ASSESSMENT REPORT

Block 11 - Central Park, Chippendale SSD 6376 MOD 5

Figure 4 – The proposed Level 13 layout with the current location of plant equipment shown by the blue clouded line (source: Applicant's EIS)

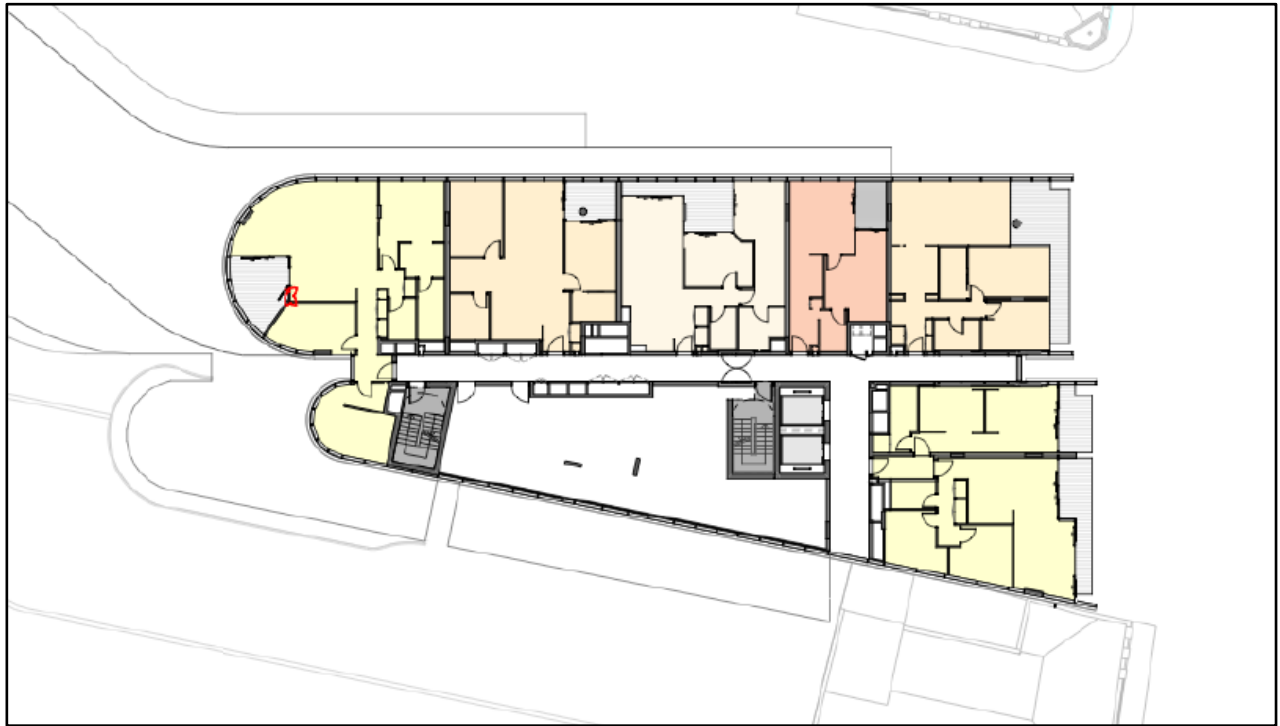
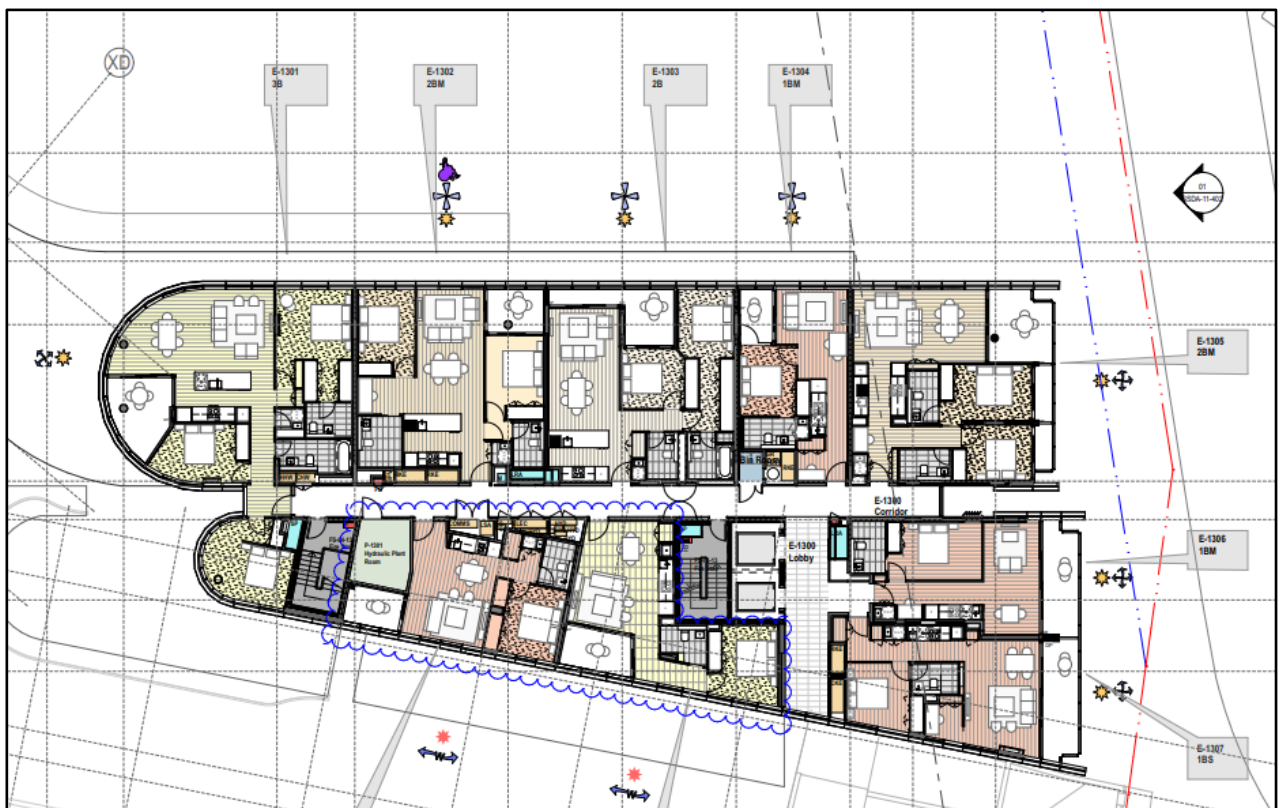
Built Form	<ul style="list-style-type: none">• The proposal seeks approval to remove the building plant located within Level 13 and replace it with 2 x one bedroom units (see Figure 4). This would increase the total number of units within Block 11 from 293 units to 295 units.			No additional conditions or

Issue	Consideration	Recommendation
	<ul style="list-style-type: none"> The Applicant notes that a significant portion of the approved plant area on Level 13 was originally intended to accommodate heat rejection equipment for the retail, childcare and community spaces. Most of this area however, is no longer needed because it will be connected to the precinct's central thermal plant which will enable more efficient heating and cooling of the building. The Department considers the proposed modification to Level 13 is acceptable as it would not change the height, bulk or scale of the approved building and it would not result in any adverse environmental impacts on adjoining neighbours. Further, the connection of the building to the precinct's central thermal plant will enable more efficient heating and cooling of the building, improving its sustainability. 	amendments necessary.
<i>Residential Amenity</i>	<ul style="list-style-type: none"> The Applicant provided a detailed assessment of the proposal against SEPP 65 and the provisions of the ADG. The assessment demonstrates the additional units generally maintain compliance with the ADG. In particular, the Department notes Units E1308 and E1309 are 53 m² and 50 m² in area, respectively. This meets the minimum size requirement of 50 m² for one bedroom apartments in the ADG. However, the Department notes Unit E1309 proposes a balcony 0.5 m² below the minimum of 6.5 m². The Department considers this is a minor non-compliance and the proposed unit would otherwise have an acceptable layout, outlook and comply with the requirements of the ADG. The Department therefore considers the new apartments would achieve acceptable levels of residential amenity. 	No additional comments or amendments necessary

Figure 8 – The proposed southern elevation (source FJMT)

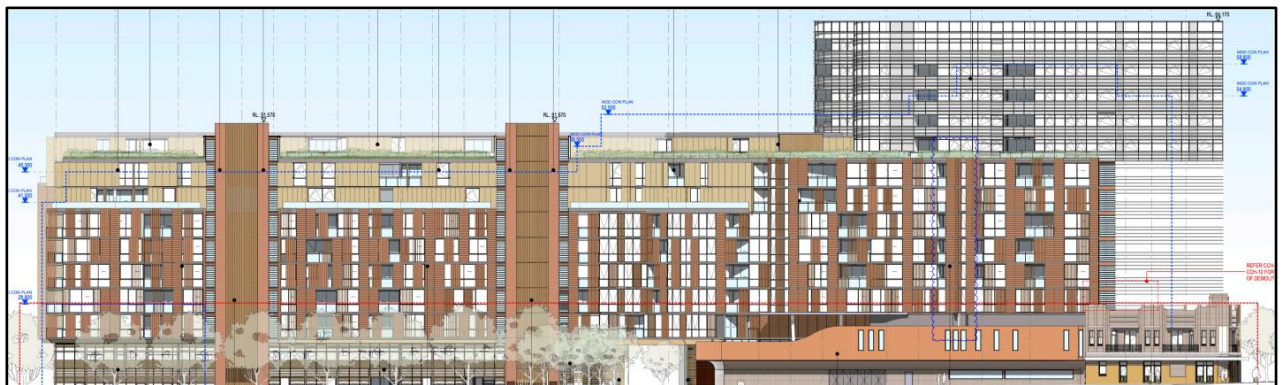
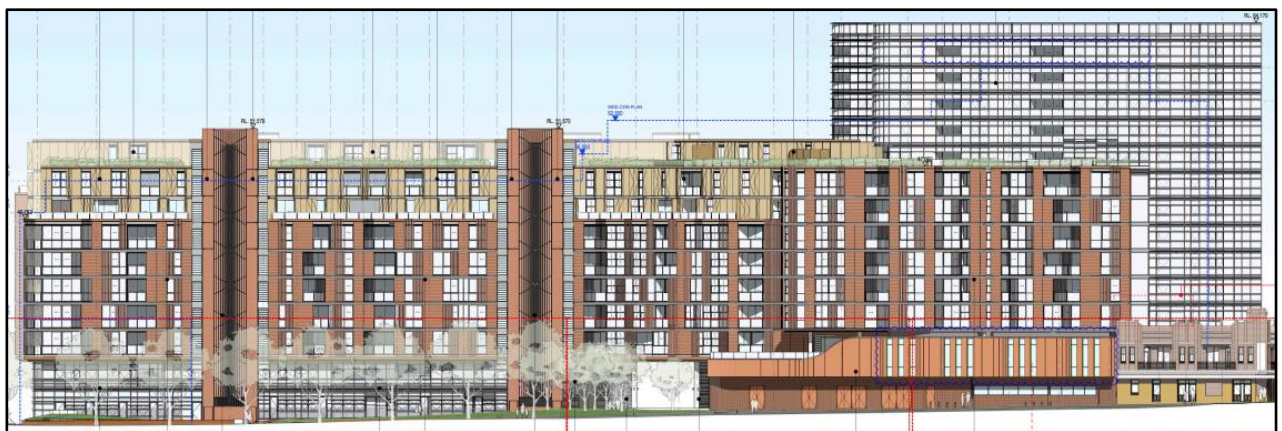
- remove Level 13 plant room services and replace with 2 x one-bedroom units (see **Figures 3 and 4**)
- modify eight units on the northern elevation by replacing loggias with balconies (see **Figures 5 and 6**)
- include additional projecting wall signage above the ground level entry to retail tenancies
- remove internal stairs (stair 5) between Ground Level and Level 1
- make minor internal and external modifications to service and plant structures
- reduce the overall GFA of the building from 25,220 sqm to 25,194 sqm as a result of additional area used for services.
